## FIELD SERVICE BULLETIN

FSB Number: BJCCFSB2006-76  
Author: Feng Joanna  
Date: Feb 28, 2002  
Total No. of Pages: 2  
Subject: **V3i Earpiece Noise\_Pflex Bezel Shorting**  
Model Affected: V3i  
Level of Repair: 2

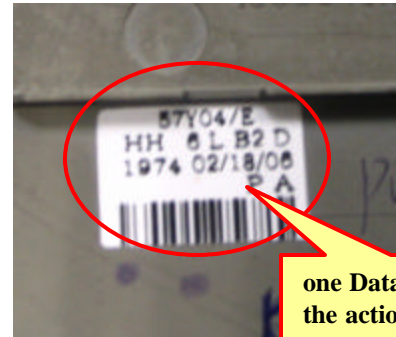
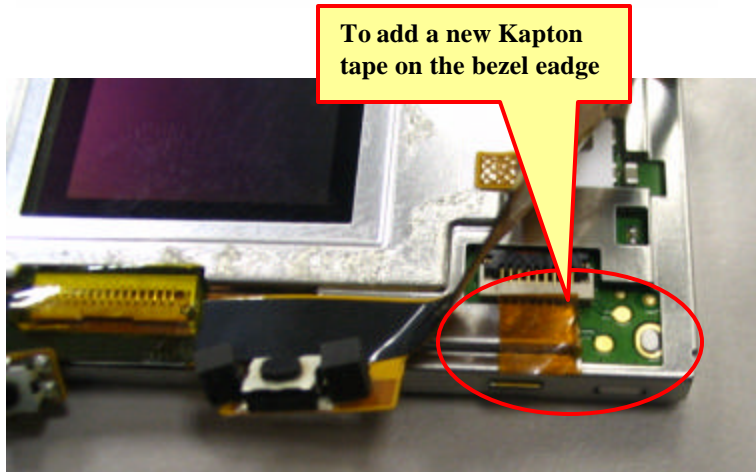
Service has been made aware of a complaint with “Audio, Earpiece noise/ distortion when making a call or pressing keys”. The root cause is the SPKR\_P line on the Pflex shorted at the metal bezel edge due to a forcing abrasion. The symptom is SPKR\_P pin short to GND (normally should be open) on the Kflex 50 pin connector before disassembly the flip. The earpiece performance quality will recover after disassembly the flip.

A nick was found at the SPKR\_P line on the edge of the bezel, which caused SPKR\_P short to GND.

The defect could be prevented because Foxconn should add an new Kapton tape on the bezel edge from Feb 13, 2006.

When servicing any V3i customer return with described issue, check the bar code label on the front housing assembly. If it is before 02/13/06, replace the Pflex and add a Kapton tape on the bezel edge. The part No. is 8489906Y01. Otherwise, please follow normal troubleshooting procedure on this unit or send it to Motorola for further analysis.
